RE: Enterprise Recycling and Disposal Facility
Cell 16 Construction Completion Report
Response to 10/30/18 RAI
Permit No.: 177982-023-SC/T3, Pasco County
WACS No.: 87895

RE: Enterprise Recycling and Disposal Facility
Cell 16 Construction Completion Report
Revised Report per 10/30/18 FDEP Comments
Angelo's Aggregate Materials, Ltd.
FDEP Permit Nos. 177982-023-SC/T3
WACS No.: 87895
Pasco County, Florida

FIGURE
3

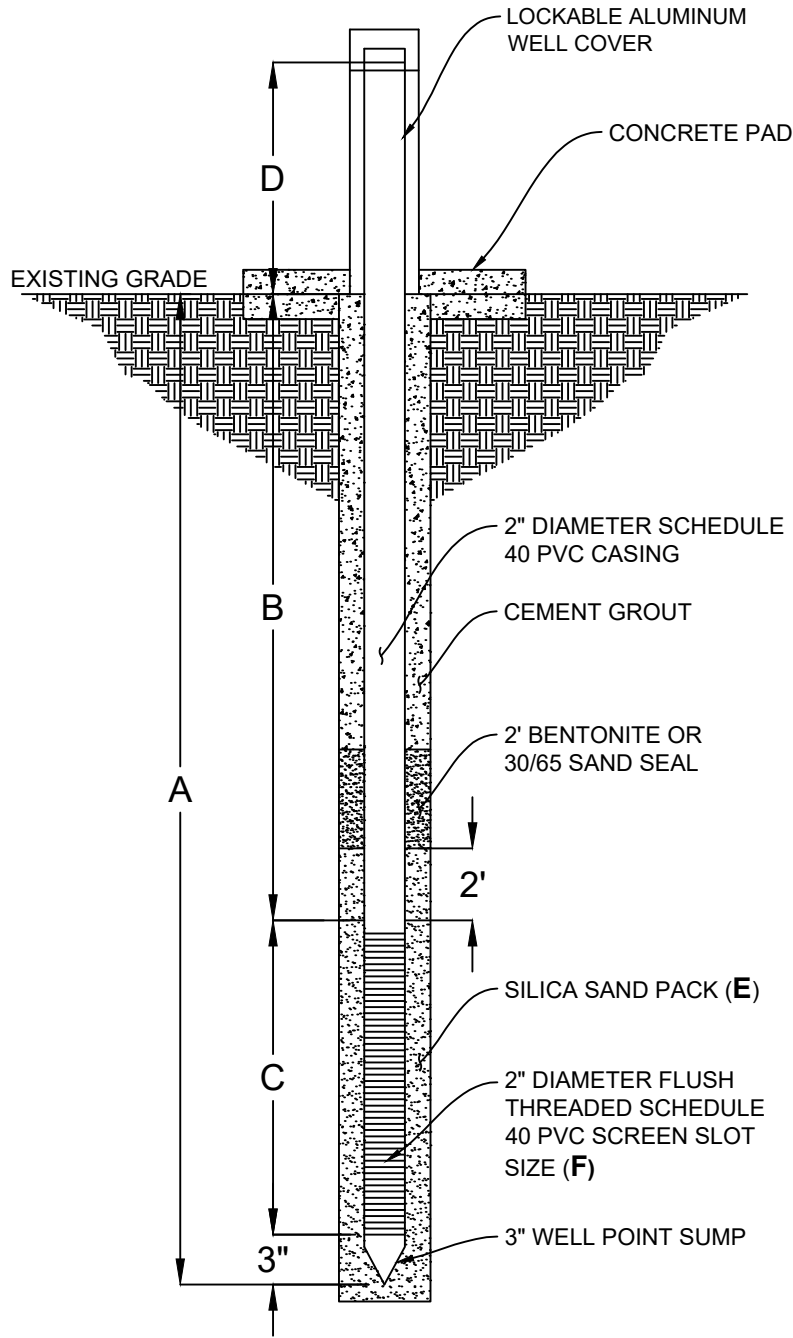
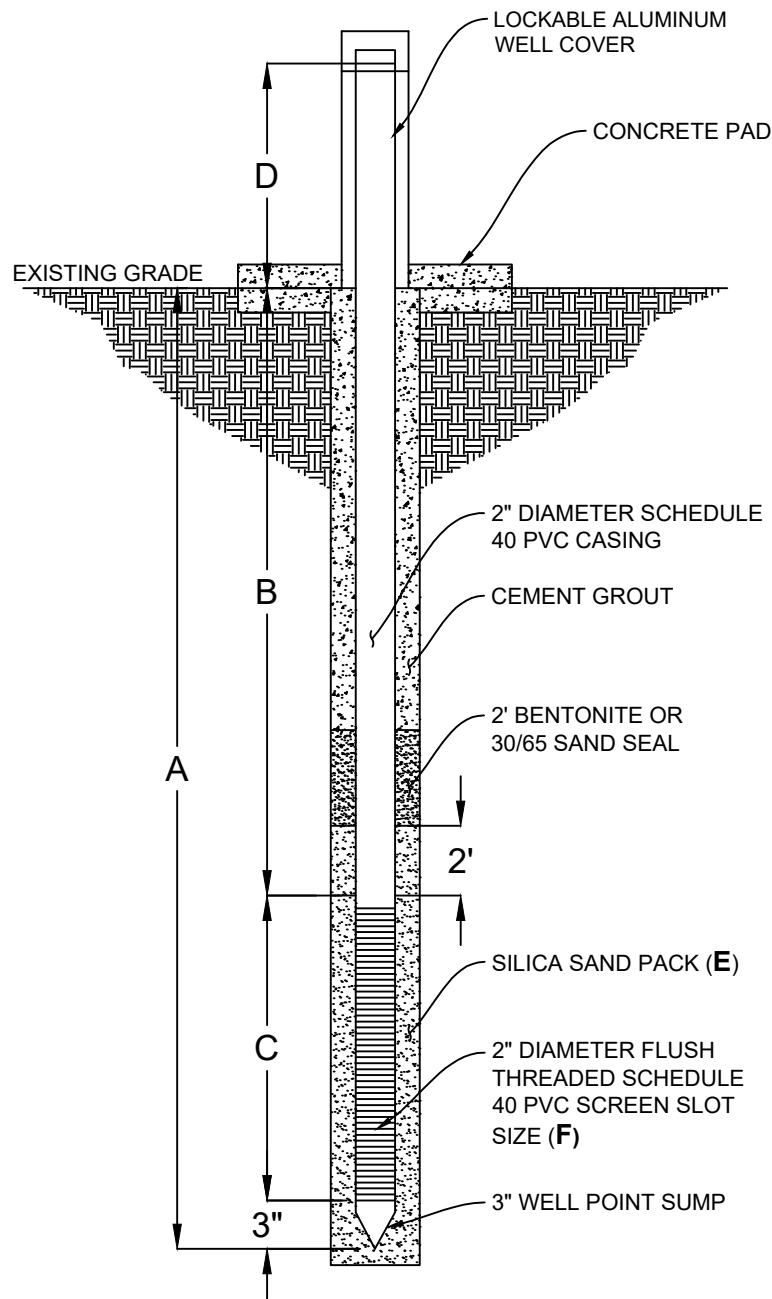
located in degrees, minutes and seconds of latitude and longitude, and the elevation of the top of the well casing and ground surface by the well casing to the nearest 0.01 foot, using an industry approved datum. b. Figures 2 & 3:

- 1) Revise figure title to remove "Proposed".
- 2) Update facility name to "Enterprise Recycling & Disposal Facility"
- 3) The figure indicates December 2016 was the date it was revised; please update to the current revision date.

- 4) The figure indicates that measurement "D" is from the top of the well cap (not casing) and extends to the top of the concrete pad (not existing grade/ground surface). Likewise, measurement "B" is shown as extending from the top of the concrete pad to the bottom of the PVC casing. Please verify that measurements "B" and "D" are from the concrete pad and well cap (measurement "D") and not from existing grade/ground surface and the top of well casing and revise figure as applicable.

- 5) Column "D" of the included table indicates only 3-inches of casing stickup. Please verify or revise as applicable.
- 6) The following columns of the included table need to be updated with actual elevations extrapolated from the survey data and boring field logs:

- a. Top of Screen Elevation
 - b. Bottom of Screen Elevation
 - c. Ground surface Elevation
 - d. Limestone Surface Elevation
- 7) The "Notes" provided on these figures appear to not be applicable to the installed monitoring wells MW-5AR and MW-5BR. Please revise the notes as applicable.

RESPONSE: The requested changes have been made to the MW-5AR and MW-5BR documentation with the exception of the items related to the survey information. Locklear & Associates has scheduled the wells to be surveyed and will provide copies of updated documentation to the Department under separate cover. Copies of the revised documentation are provided in Attachment D.

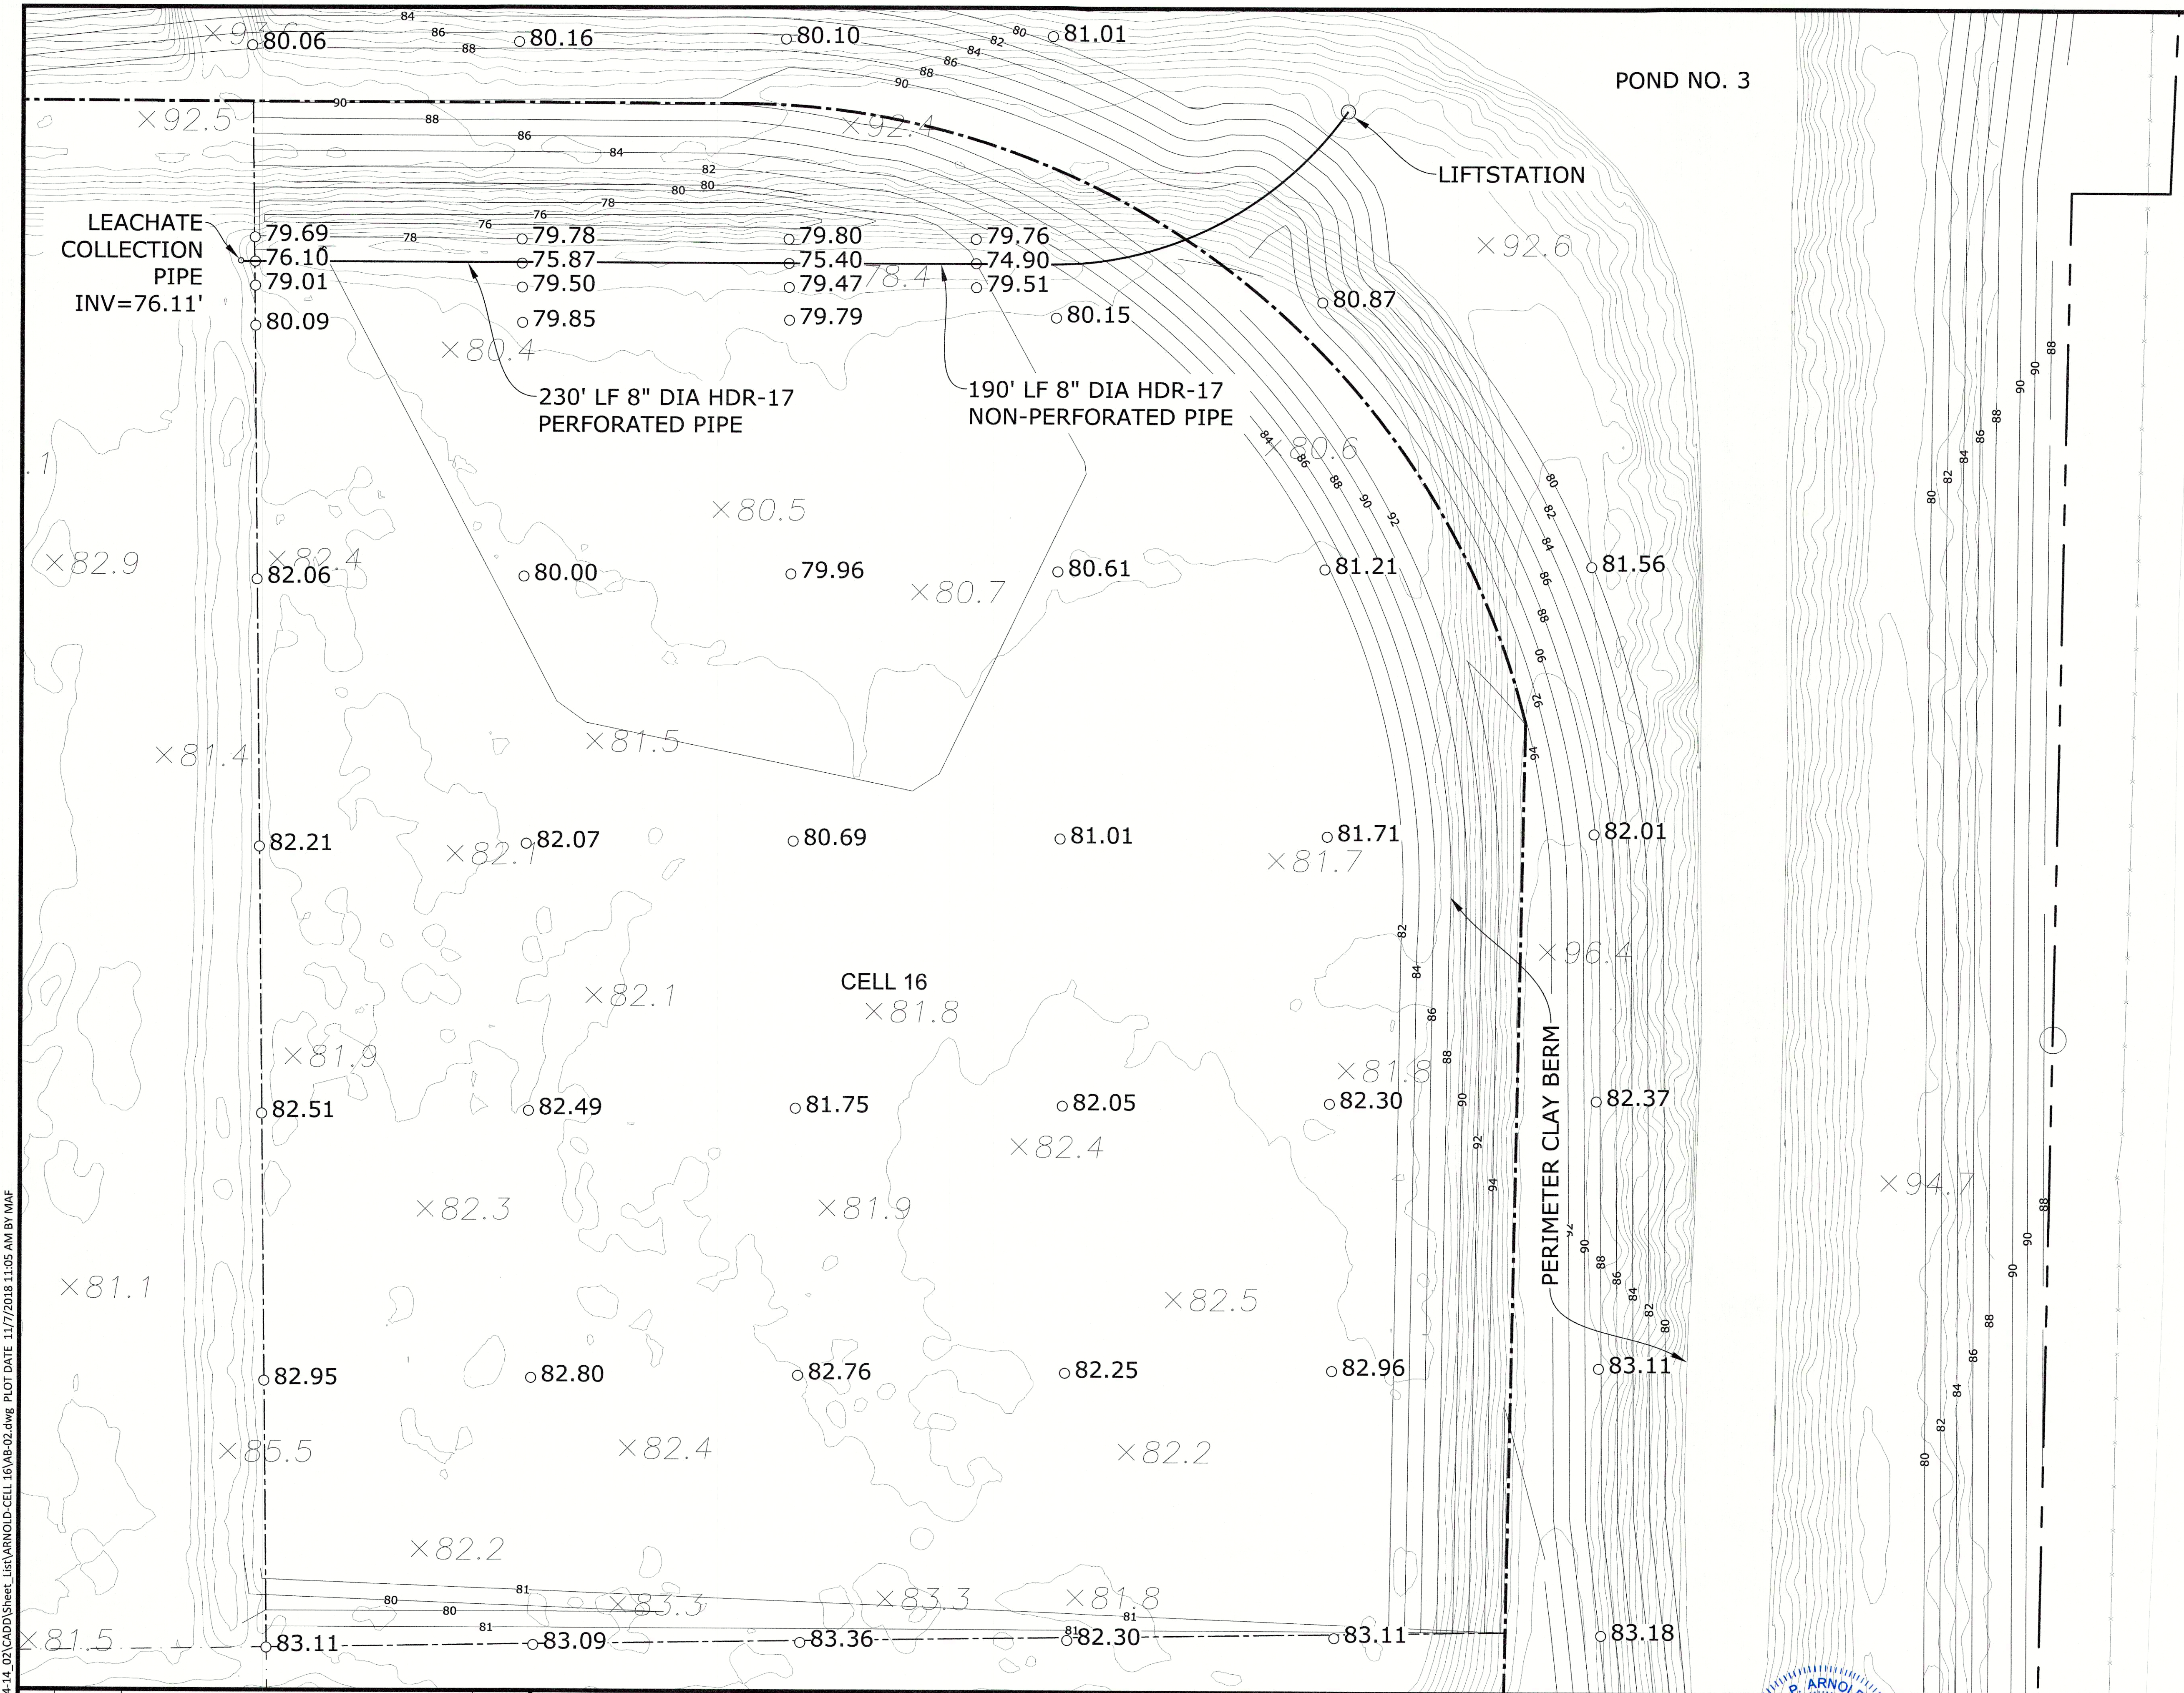
3. **Cell 16 Top of Clay:**

- a. An-built survey of the clay perimeter berm is not provided on this drawing and does not appear to have been provided in the certification report. Please verify and provide an as-built survey of the clay perimeter berm.

- b. The top of clay elevations provided on this drawing appear to be inconsistent with the survey elevations for Cell 16 presented on the Pickett October 2018 topographic survey. Please verify and explain this apparent discrepancy.

RESPONSE: Drawing AB-02 has been revised to include the as-built conditions of the clay perimeter berm.

RESPONSE: We discussed the apparent elevation discrepancies with Mr. Jeff Young with Pickett Surveying and Associates, Inc. Mr. Young's explanation of the apparent differences between the data sets is provided in Attachment E. The apparent differences between the Pickett October 2018 survey and the spot elevations recorded during construction are within the acceptable tolerances.
